Introduction

This Technical Brief provides information on the enhancements made on the ISL12022MA versus the ISL12022M.

FIGURE 2. ISL12022MA PINOUT

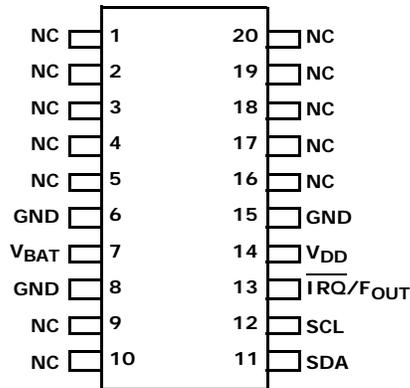
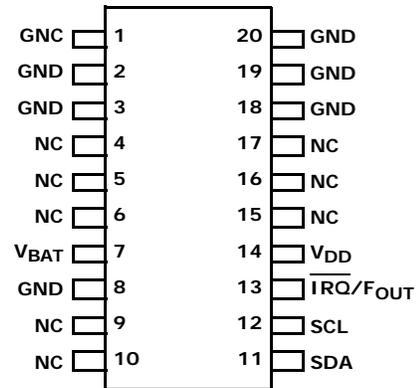
After technical analysis, a minor redesign of the lead frame to address antenna effects was implemented. Testing has demonstrated successful operation under the Contact Discharge test with ESD levels in excess of 12kV. Operating in the recommended layout, a circuit using the ISL12022MA has demonstrated that the device meets the requirements of the IEC standard.

After receiving feedback from customers regarding functional issues related to flux residue, the design of the ISL12022M module package was evaluated with consideration given to leakage currents. Additional improvements were implemented to minimize the impact of this issue on the operation of the device. Bench evaluation and testing demonstrates that the upgraded ISL12022MA operates dependably in the presence of highly elevated moisture levels. Very large amounts of accumulated flux residue can still cause functional issues, however, users will find that manufacturing flows following the most basic cleaning procedures, followed by the application of a conformal coat for extra protection, will result in dependable operation.

In order to take maximum advantage of the enhancements discussed above, users can follow the grounding layout shown in Figure 2. Note that this enhancement incurs no functional change to the operation of the device but only provides improved ESD performance under requirements of IEC61000-4-2, and greater reliability and reduced sensitivity to board leakage in applications requiring operation in environments involving condensing moisture. There is no need for users satisfied with the operation of the ISL12022M to switch to the ISL12022MA, unless they wish to take advantage of these enhancements.
